Waiver Review

15-110SPR/WR – BSD Residential District

Tuller Flats Apartments

4313 Tuller Road

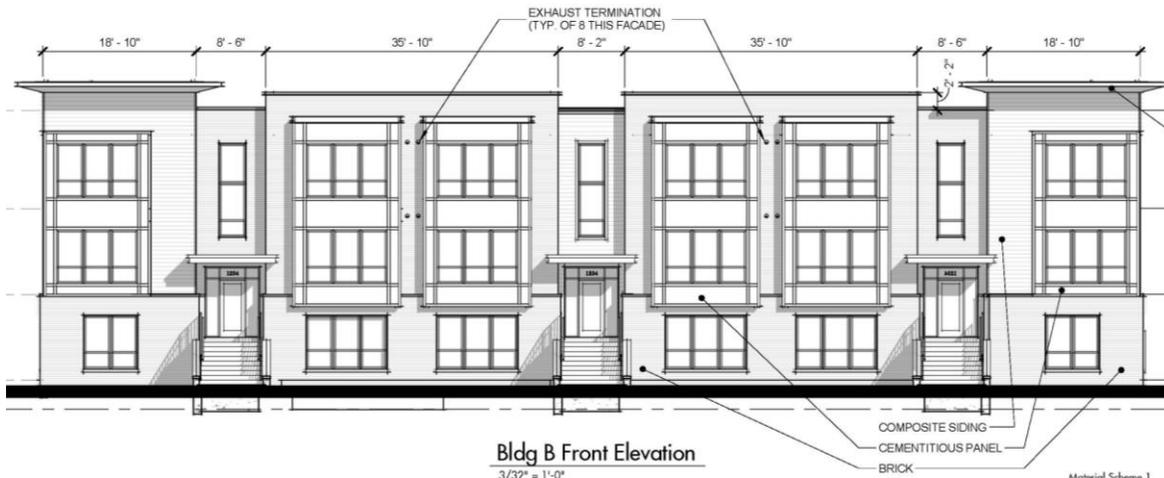
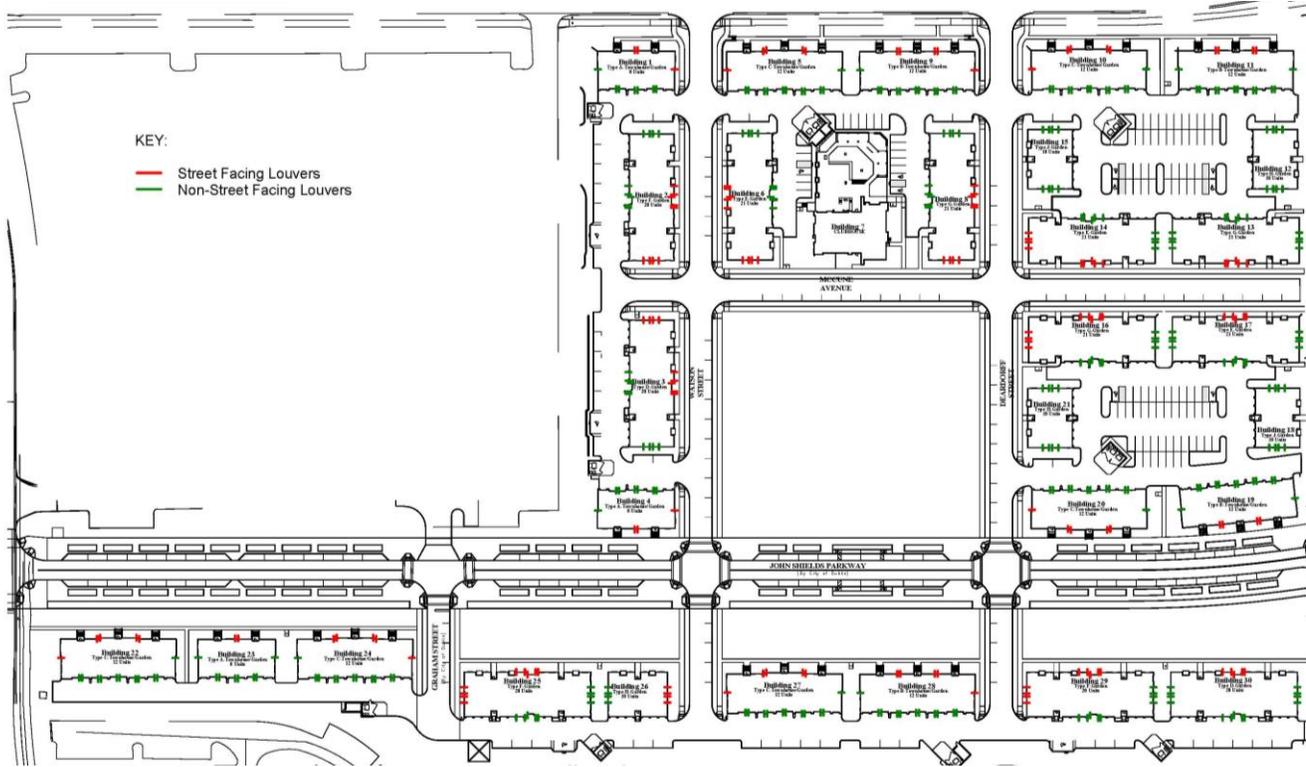
Mechanical System Louvers. The ART’s evaluation of this waiver, to allow mechanical system louvers on street facing facades, is viewed as a conflict between the building design and the code requirement which is the result of unavoidable or unalterable site conditions. Due to the layout of the neighborhood street blocks and the townhouse style of the architecture and dual loading of the interior spaces, conditions are created where the internal living space layout places the mechanical, bathroom and kitchen equipment adjacent to

street facing facades. The vents for mechanical systems are located on the nearest exterior walls to provide efficiency of operation for those systems.

The following plan identifies the locations of the louvers.

Through coordination with Building Standards the location of the louvers on street-facing facades has been minimized to the extent possible using best Mechanical and Electrical and Plumbing engineering practices. Louvers have been chosen which are roughly 6 inches in diameter and will be painted to match the adjacent material colors.

The Administrative Review Team has conducted its analysis of the project based on the information submitted and recommends **approval** to the Planning and Zoning Commission for a waiver to allow mechanical systems louvers on street facing facades.

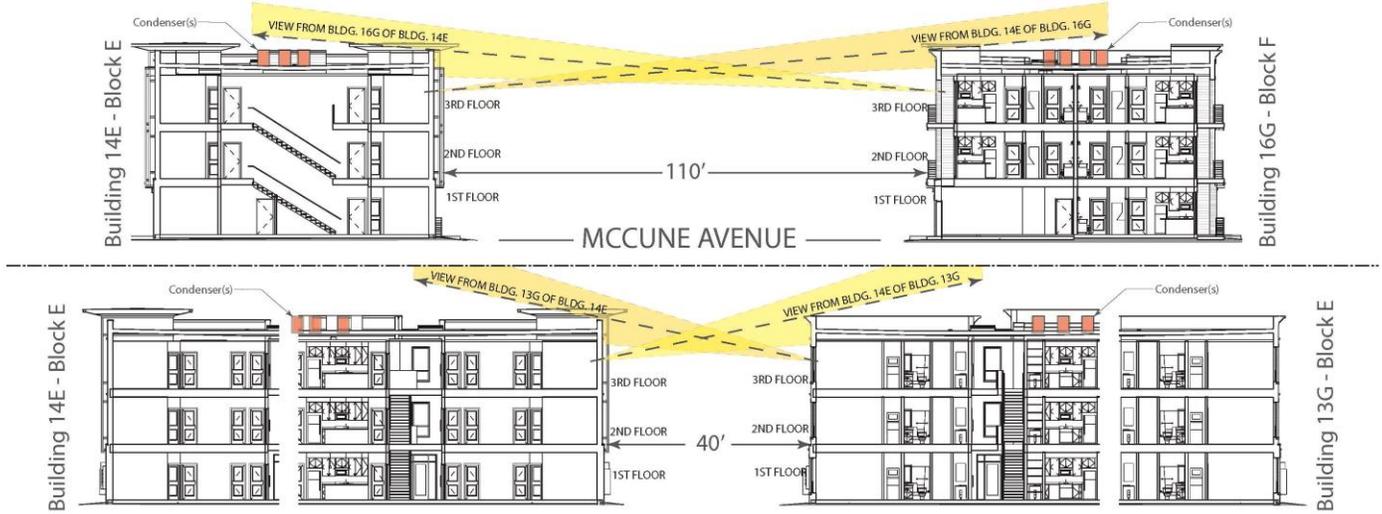
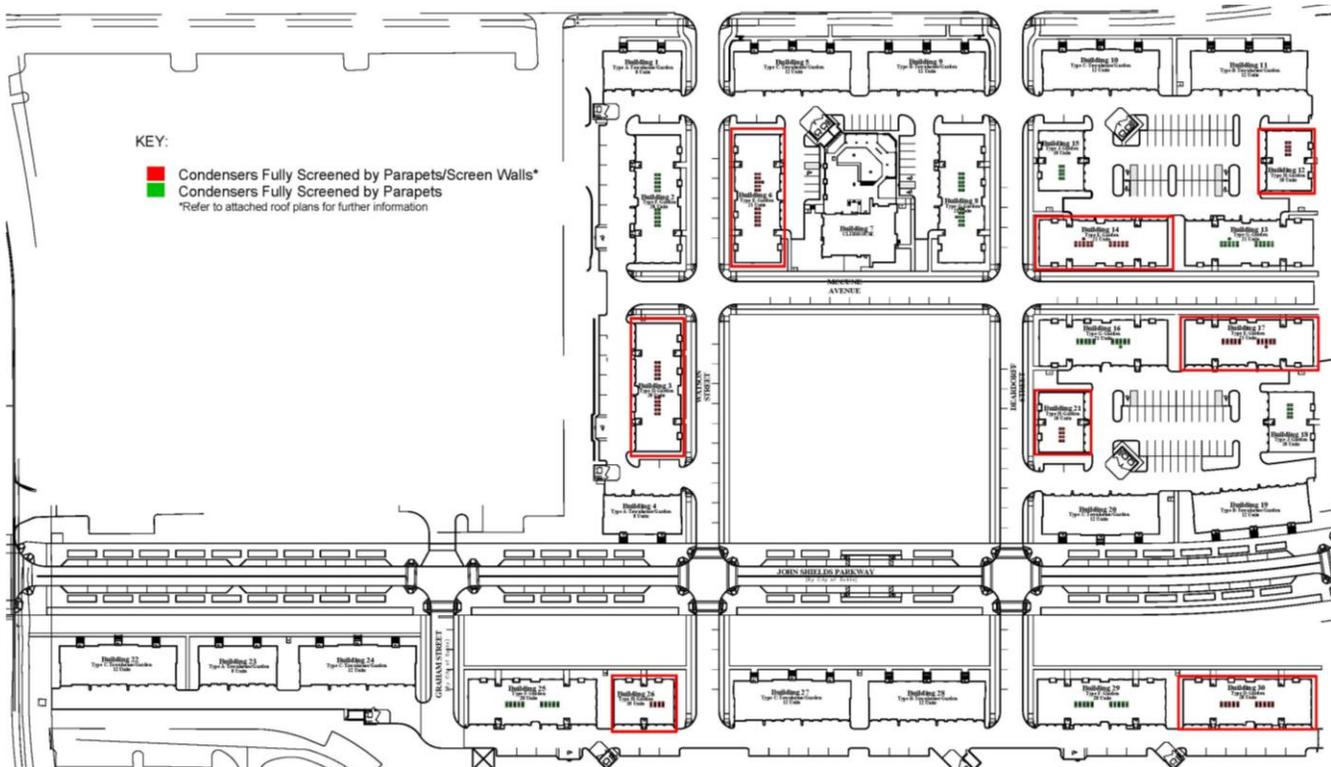
Mechanical Rooftop Screening. ART's evaluation of the request to waive the requirements for screening of mechanical rooftop systems focused on the locations where the parapet height is not at least as tall as the height of the mechanical equipment being screened. Due to the design process, the design for the mechanical systems was not complete at the time of Planning & Zoning Commission review and approval for the site plan and architectural design. The mechanical systems submitted for permitting are 35 inches in height, which is 9 inches taller than the 24 inch tall parapet. This creates a condition where the parapets no longer meet the code requirements for screening of sight lines to the interior of the roof top mechanical systems.

Street views have been provided to demonstrate compliance with the intent of the code requirement.

The applicant has also provided diagrams that seek to demonstrate that the current parapet height, coupled with the interior location of the rooftop mechanical systems meets the stated requirement of the code that the systems shall not be visible from the street or adjacent buildings of similar height.

This condition occurs for building types D, E & H, as identified in the following plan.

After review of the submittal documents and the applicants' description of the waiver request, the ART consensus was that relief from this requirement could set a precedent for the relaxation of the rooftop screening requirement and place staff and applicants in a position where each and every situation would have to be heavily diagrammed for review both at site plan approval and again at permitting.

The Administrative Review Team has conducted its analysis of the project based on the information submitted and recommends **disapproval** to the Planning and Zoning Commission to waive the requirement for screening of rooftop mechanical systems.
